Alaris™ Pump module Model 8100

Frequently Asked Questions (FAQ's)

BD is issuing this letter to inform you of a potential risk associated with the Alaris™ Pump module. We have identified a specific scenario that could cause unintended flow in the older, centered sear door latch design in the Alaris Pump module model 8100. This scenario is reproducible under the following situations: a) the user does not close the roller clamp on the IV administration set before the pump door is opened as recommended, and b) opening the pump door using an atypical technique with the door latch with the centered sear design. The following FAQs are for the customer letter dated on June 12, 2017.

Image of Centered-Sear Safety Clamp Fitment
(Affected Product)

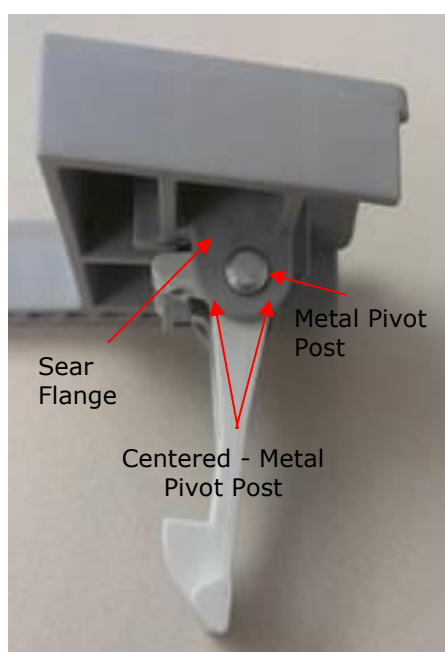
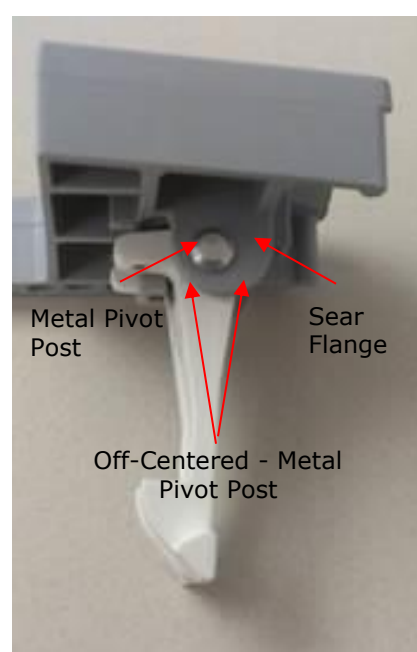
User can reproduce a free-flow condition if the clinician does not close the roller clamp on the IV administration set prior to opening the pump door and the pump door is opened by using a "flick" of the door latch that causes the door to "pop" open instead of opening the door by slowly raising the latch. This flicking motion may cause the centered sear design to not effectively engage with the safety clamp fitment.

16. How can the user visually identify the Alaris Pump module door latch for a centered-sear?

The centered-sear safety clamp fitment is identified by the centered position of the metal pivot post located on the inside of the door latch assembly sear flange.

If an affected pump has already been replaced with an off-centered safety clamp fitment, then the pump does not need to be remediated.

Image of Off-Centered-Sear Safety Clamp Fitment
(Current Production)
